**YARRA CITY COUNCIL**  
**Internal Development Approvals Committee**  
**Agenda**

**to be held on Wednesday 28 February 2018 at 6.30pm  
in Meeting Rooms 1 & 2 at the Richmond Town Hall**

**1.1 PLN11/0648.02 - 221 Kerr Street, Fitzroy - Amendment to the endorsed plans, including a larger terrace at level 3, the modification of dwelling layouts, car park levels and window locations**

Drawing title  
DESIGN RESPONSE  
PROPOSED PLAN LEVEL 3

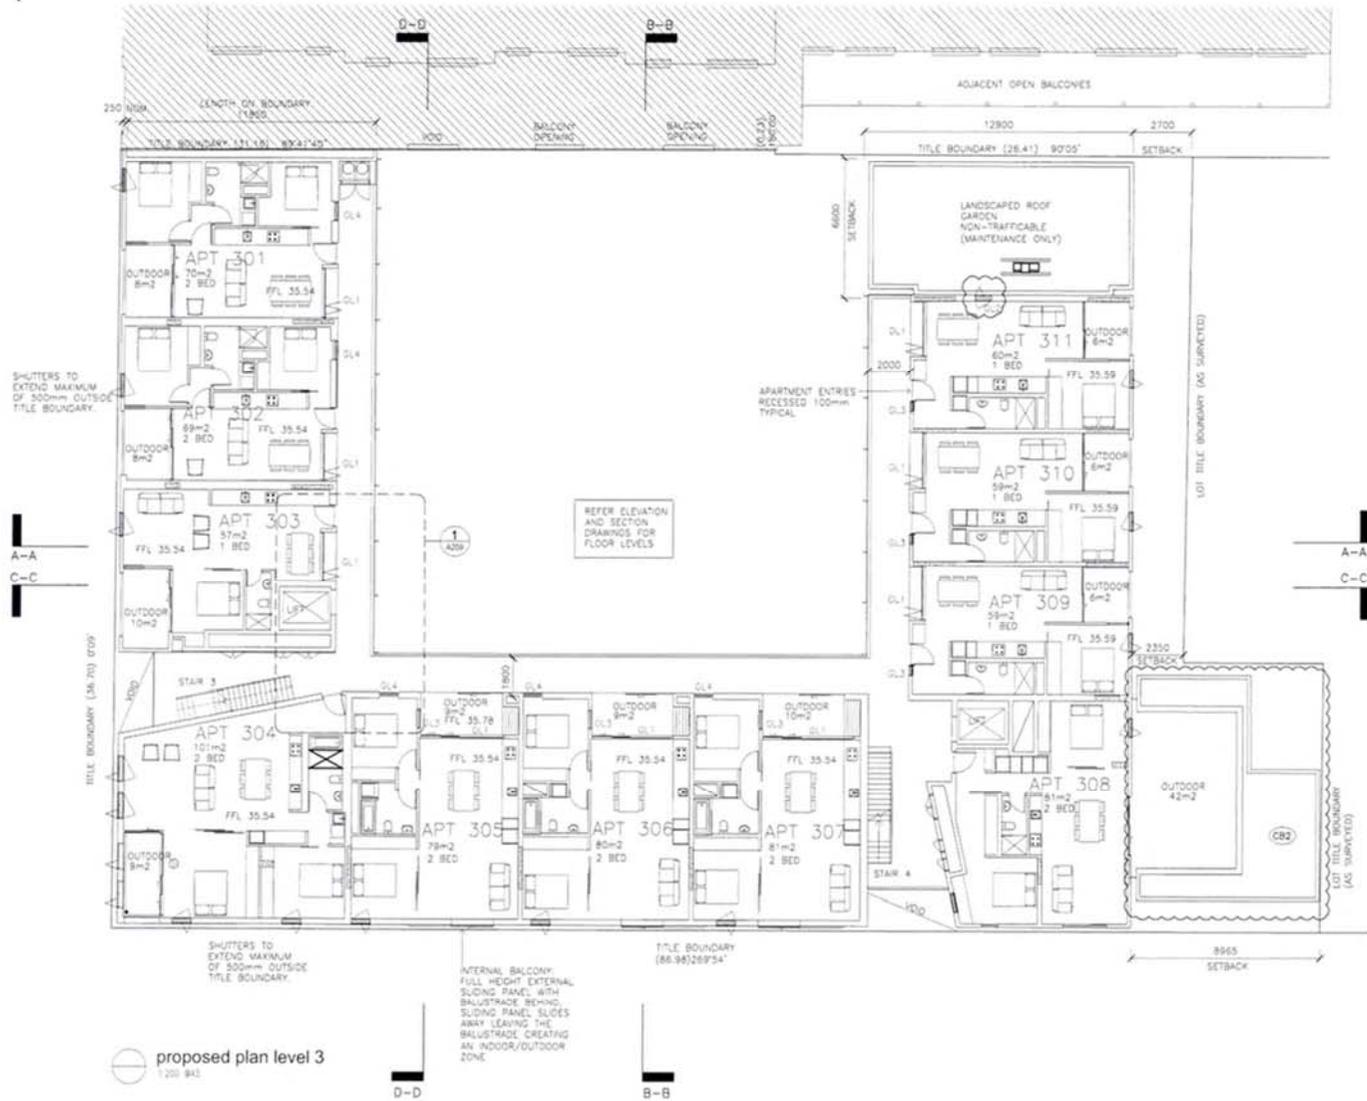
- (c) apartment 206 reconfigured, with the outdoor area revised from 28m<sup>2</sup> at the northern edge to 27m<sup>2</sup> in an L configuration to the north and east of the apartment. At level 3 above, the terrace in south-east corner would then be revised from an east-west to a north-south axis and increased in size from 36m<sup>2</sup> to 42m<sup>2</sup>. This would increase the east boundary wall height by 1.2m to 12.96m;

*Apartment 206 reconfigured, with the outdoor area revised from 28m<sup>2</sup> at the northern edge to 27m<sup>2</sup> in an L configuration to the north and east of the apartment. At level 3 above, the terrace in south-east corner would then be revised from an east-west to a north-south axis and increased in size from 36m<sup>2</sup> to 42m<sup>2</sup>. This would increase the east boundary wall height by 1.2m to 12.96m.*

47. The appearance of the building would not change significantly as the terrace opening would simply be glazed to allow for window. There is therefore no unreasonable urban design or heritage consequence as a result of this change.

drawing title  
DESIGN RESPONSE  
PROPOSED PLAN LEVEL 5  
project  
RESIDENTIAL DEVELOPMENT  
# 221 KERR STREET FITZROY  
for BILKERR PROPERTY P/L  
date JAN 2018 drawn by LD drawing no. rev  
scale 1:200 project KERR A106 TP10  
e:/kta/projects/  
copyright 2012

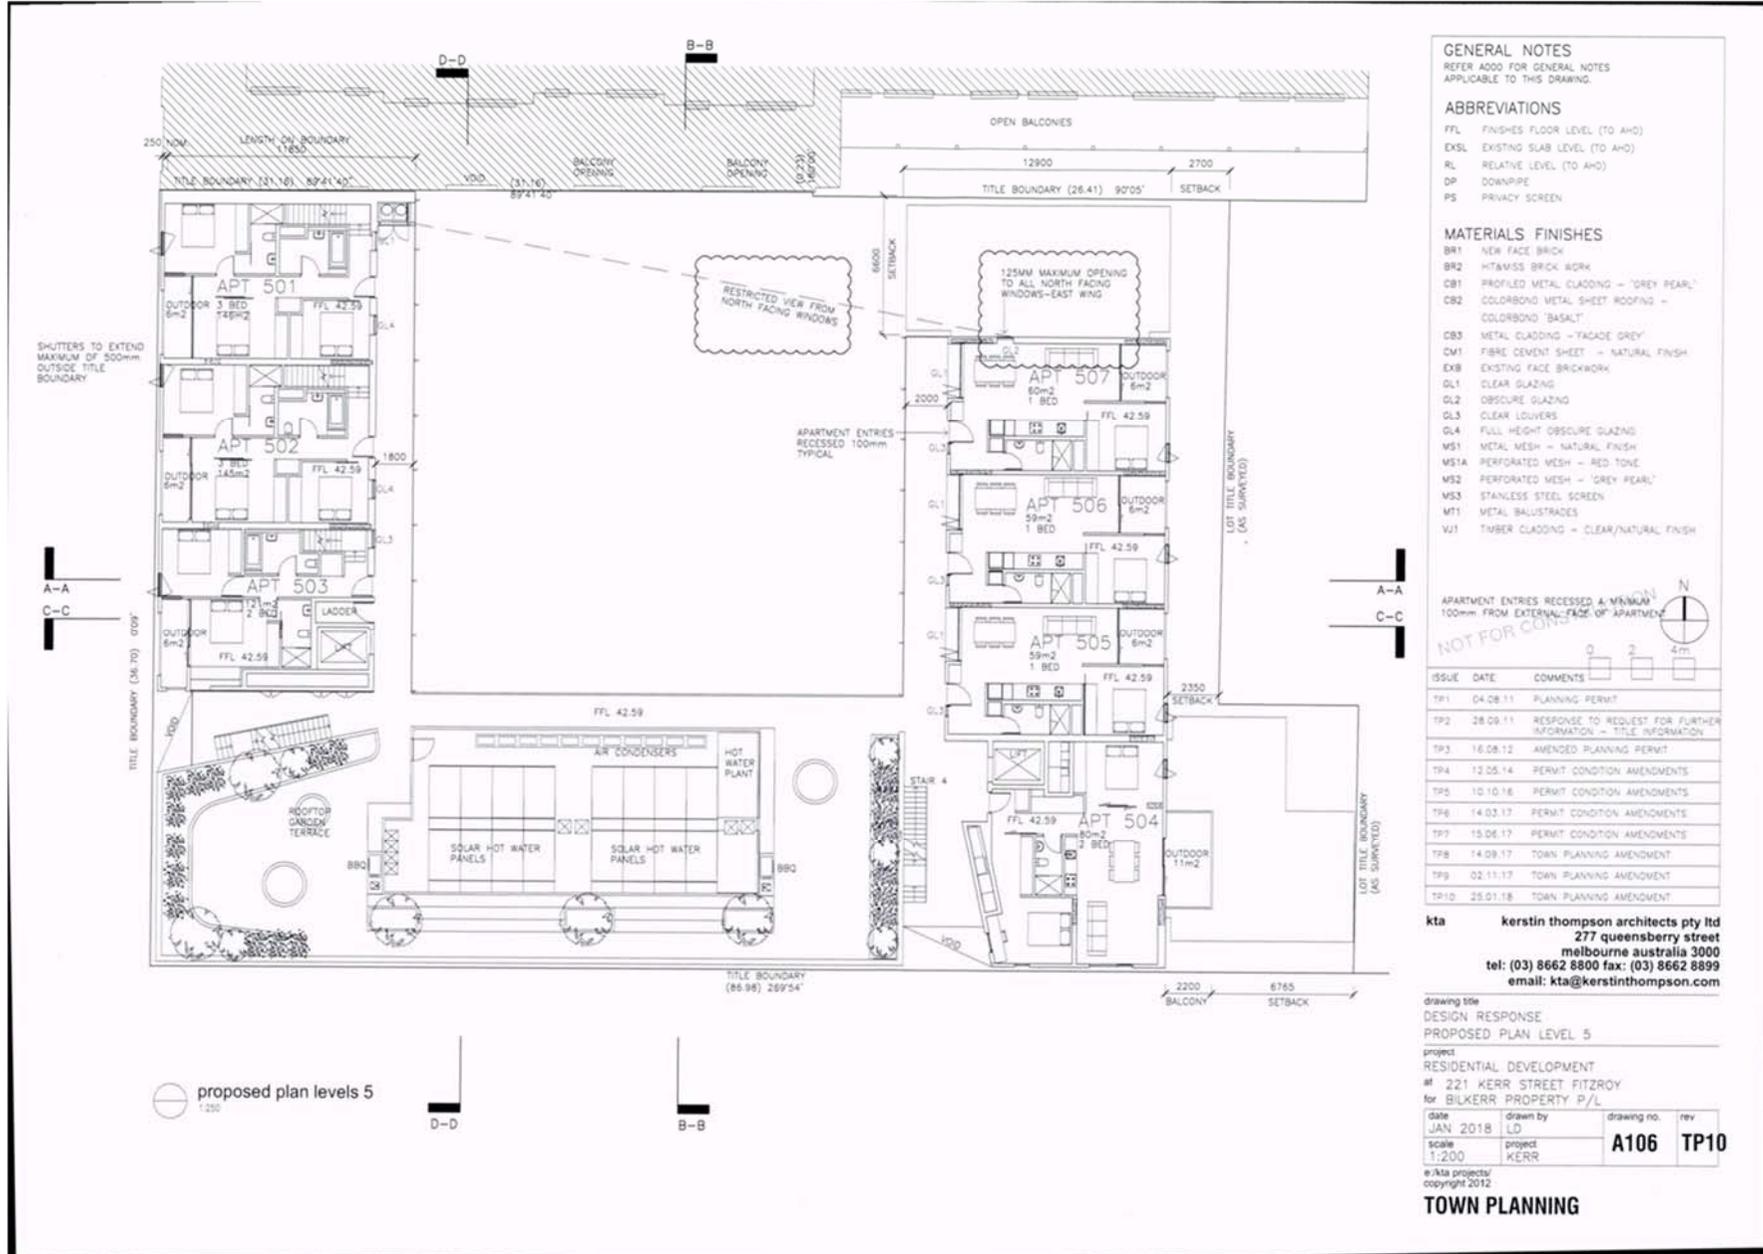
*Increase in the height of the level 3 north-east corner parapet by 500mm to allow for more planting*

49. The 500mm height increase did not raise any issue from a planning perspective as it is to the south of terraces (continuing to allow adequate daylight opportunities) and not result in unreasonable visual bulk, however the offer to reduce the height of the parapet wall (rather retain as per existing conditions) with pot plants added at least 2m from the northern boundary is supported as a reasonable compromise between the Permit Applicant and Objectors and should be imposed by way of a permit condition, should an amended permit issue.

- (i) **retain the north boundary wall height for the eastern built form segment as per the endorsed plans, with planters setback at least 2m from the northern boundary (as shown in the sketch plans received by Council on 29 January 2018);**

proposed north elevation  
1:200 (A3)

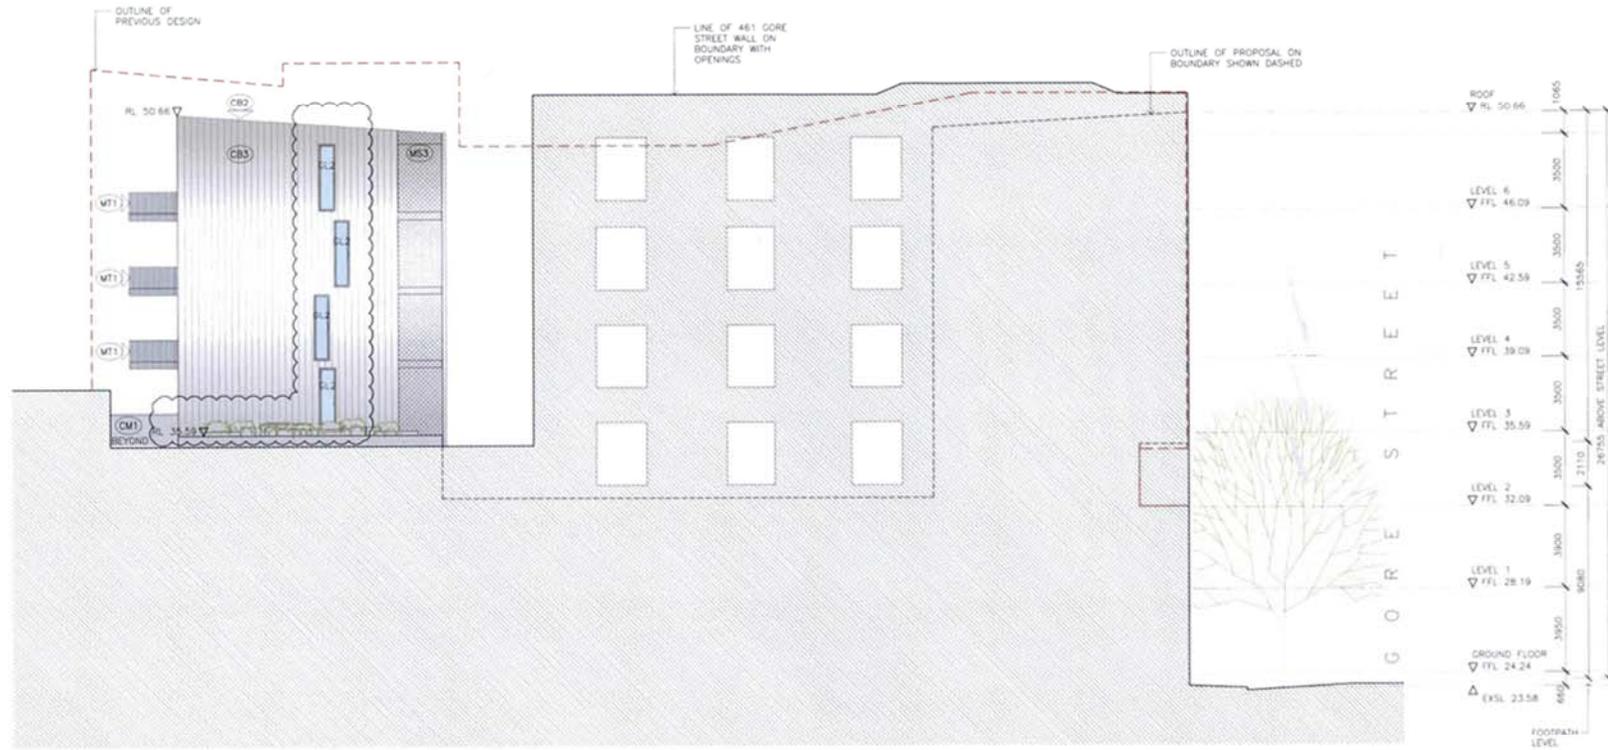
- (b) The new windows on the north elevation of the easternmost wing would be restricted to opening a maximum 125mm at their western edge to restrict overlooking.

50. The plans show that these window openings would be partially restricted, although insufficient details have been provided. Although clauses 55 and 58 do not apply, it is reasonable to consider potential adverse overlooking in this context, and even apply the 9m distance, 45 degree rule outlined in these Particular provisions.
51. Following the notice period, receipt of objections and planning consultation meeting, the Applicant provided sketch plans showing these windows would be constructed or obscure glazing and restricted to a maximum 125mm opening, directing views into the subject site, yet not within a 9m distance of any other dwelling's habitable room window or private open space area.

This is considered to reasonably provide northern daylight and ventilation to these dwellings, without unreasonably overlooking the dwellings to the north. This treatment should be imposed by way of a permit condition, should an amended permit issue.

- (ii) **restrict the opening of the new north facing, obscure glass windows to a maximum 125mm, (as shown in the sketch plans received by Council on 29 January 2018);**

**ENDORSED DRAWING**

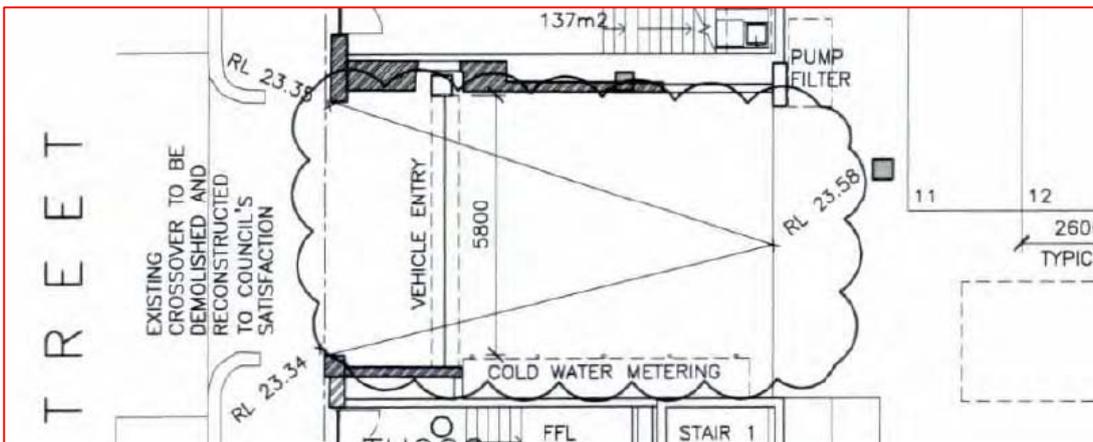
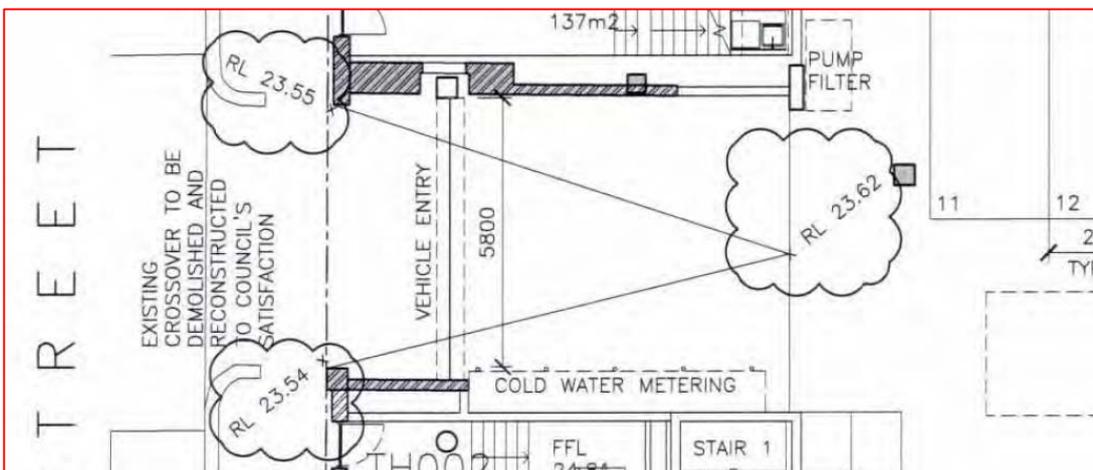
9. The application is for an amendment to the endorsed plans to:
- (a) raise the crossover edge and internal ramp grade by a maximum of 200mm;
  - (b) level 2, south-west corner deck reduced in height (FFL reduced from 32.59 to 32.09) with the addition of a seat at the eastern end;

- (o) confirm the crossover along Gore Street will be demolished and reconstructed;
- (p) a 1 in 20 scale cross sectional drawing of the vehicle crossing, extending from the road to inside the property. The drawing must show specific levels and dimensions and demonstrate that an 85<sup>th</sup> percentile vehicle profile as per AS/NZS 2890.1:2004 can traverse the proposed vehicle crossing without 'scraping out';

- (s) a ground clearance check of the crossover using a B99 vehicle, demonstrating vehicles will not scrape or bottom out;**
- (t) further modified as per the amendments shown in the advertised plans received by Council on 25 September and 6 November 2017, but modified to:**
